REPORT
TO
CASSIAR ASBESTOS CORPORATION LTD.
ON
GEOTECHNICAL ASPECTS OF MINE CLOSURE
CLINTON CREEK MINE YUKON TERRITORY

April 1978

V77016

HORIZONTAL SURFACE MOVEMENTS CLINTON WASTE DUMP

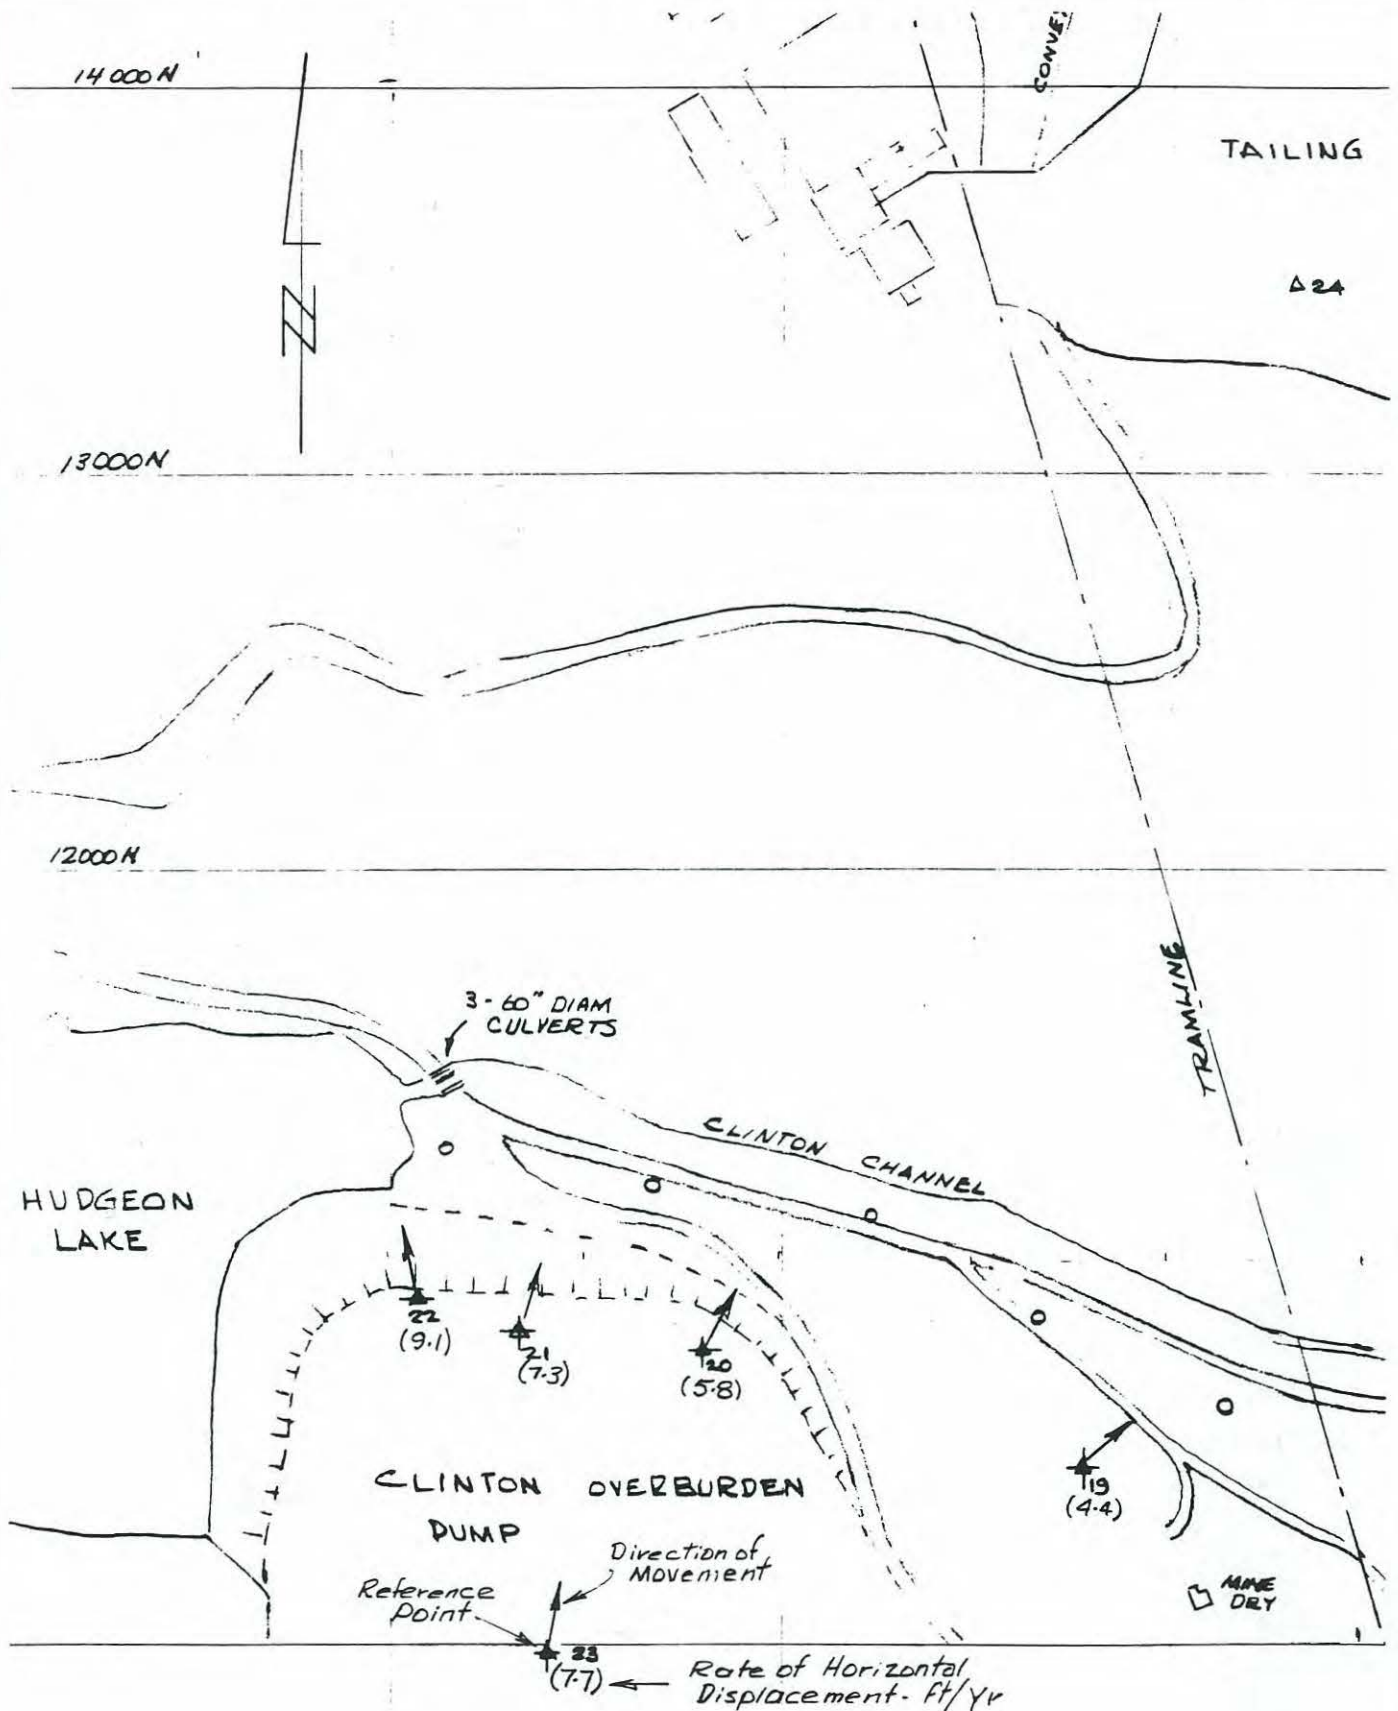
Unacceptable

SCHEMATIC CROSS SECTION
SHOWING ROCK GROYPE
TO CONTROL DOWNCUTTING OF CHANNEL

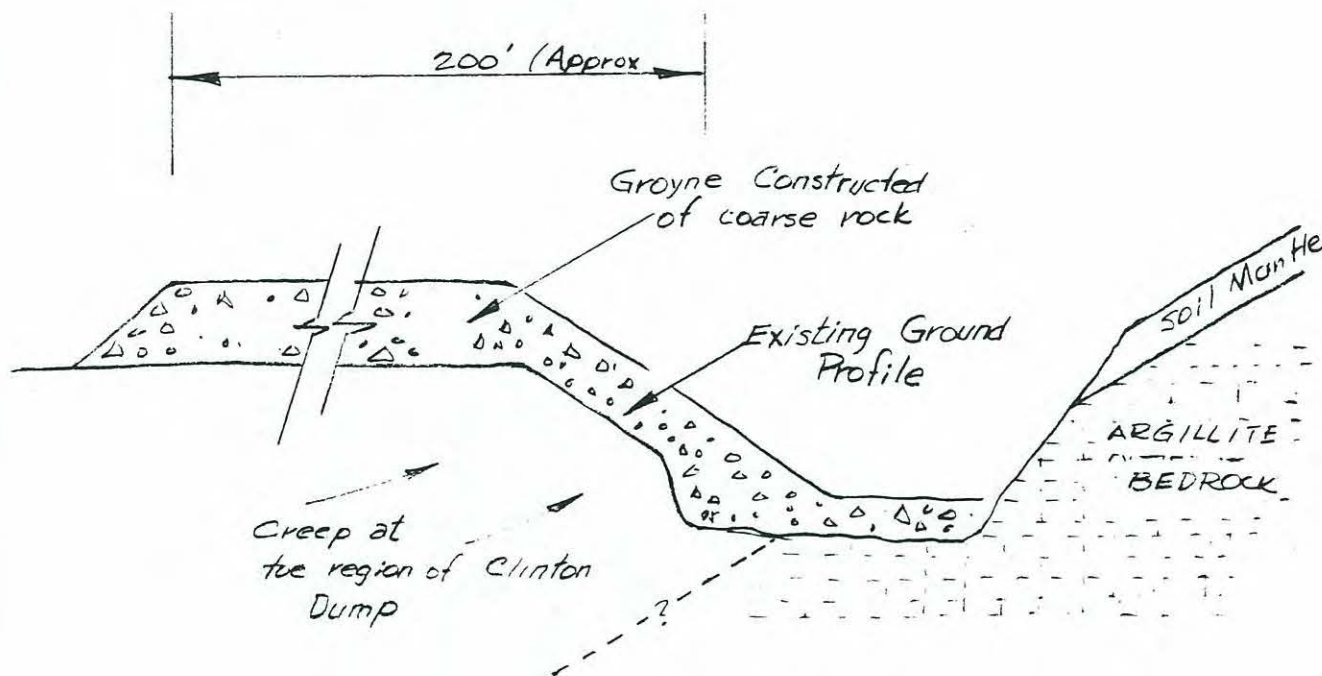
So what does this do? - erosion still on between the groynes.

HORIZONTAL SURFACE MOVEMENTS TAILING PILE

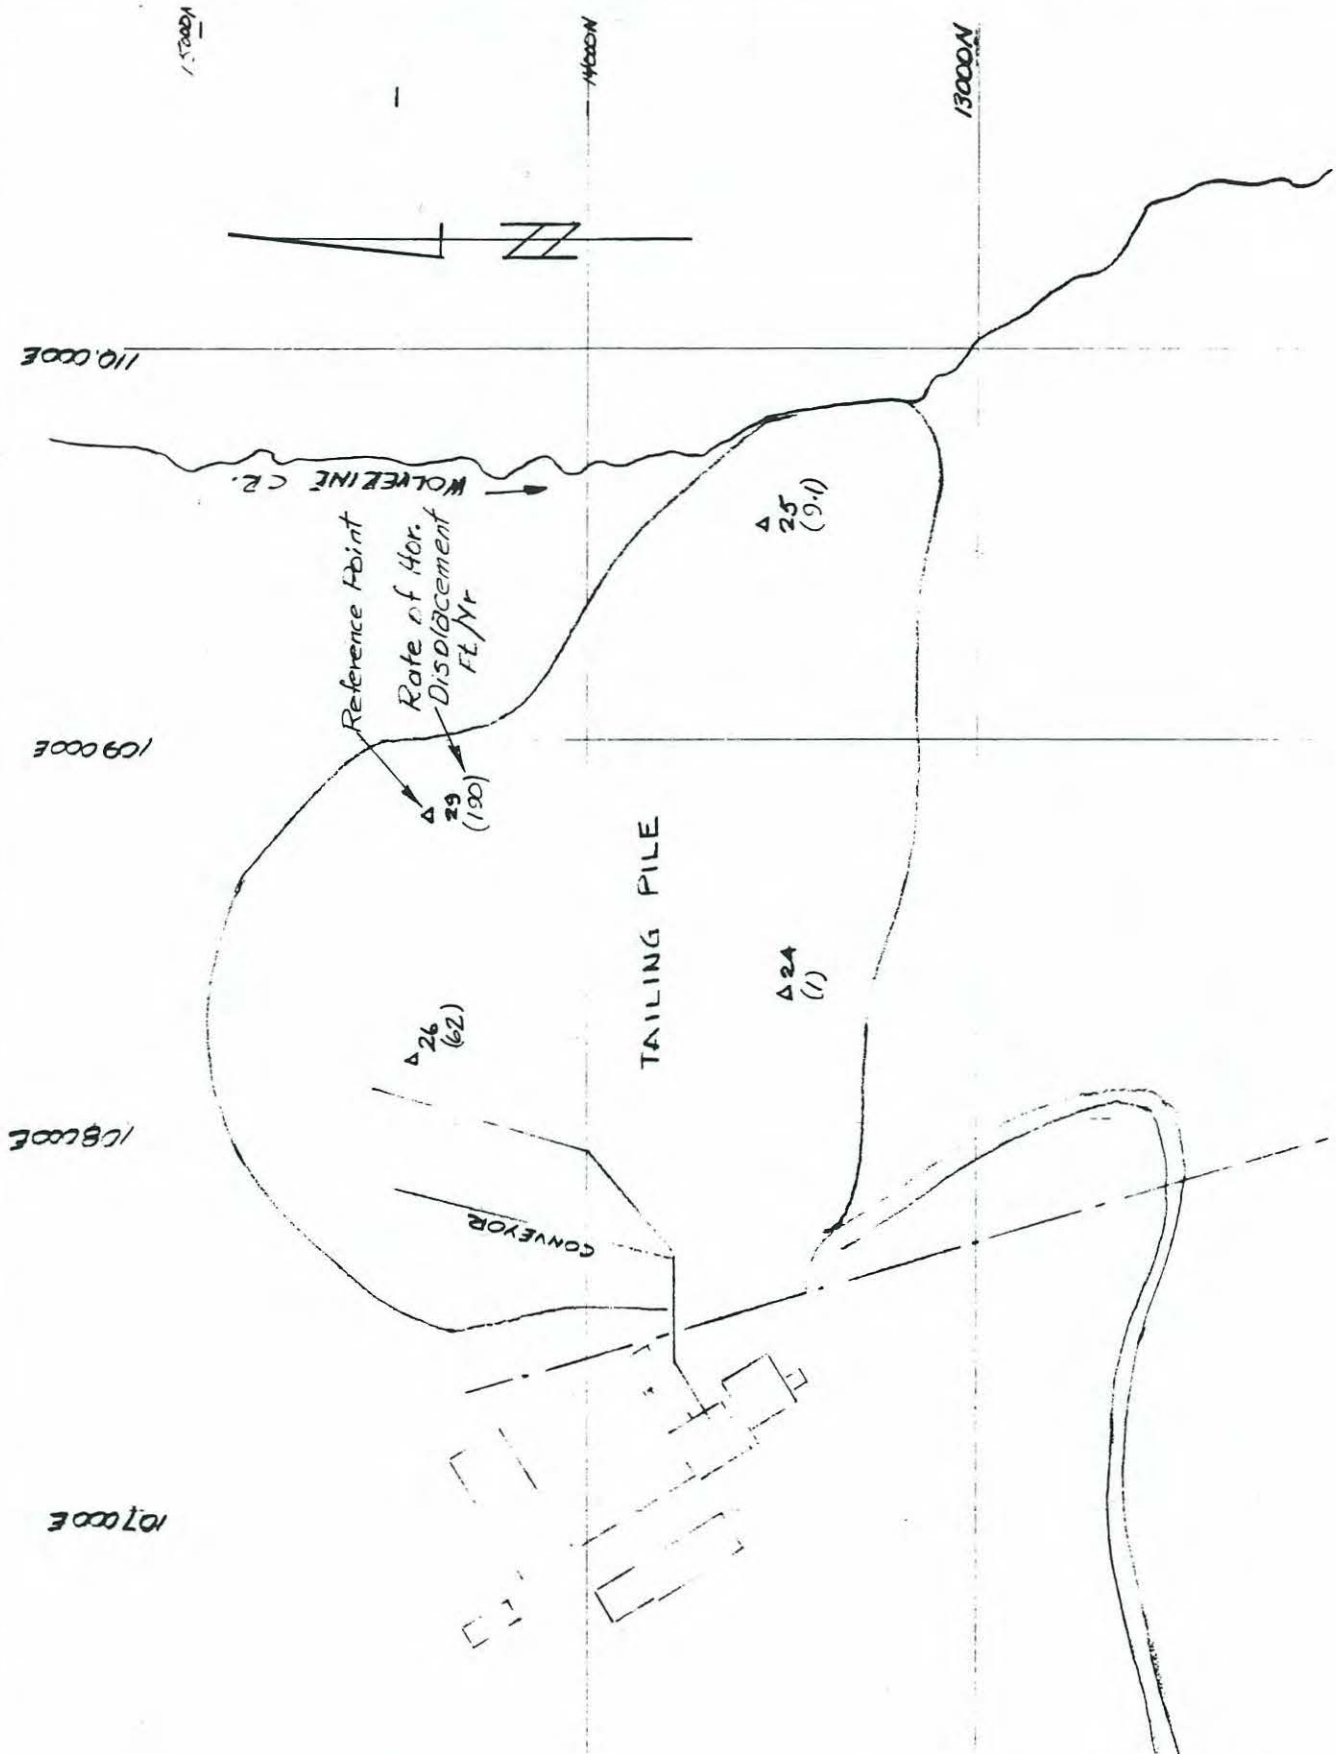
*R.M. Hardy report - All monitors a rate of movement which could be considered failure
309 day - $\Delta = 1.28$ ft Δ elev = 0.52 ft.*
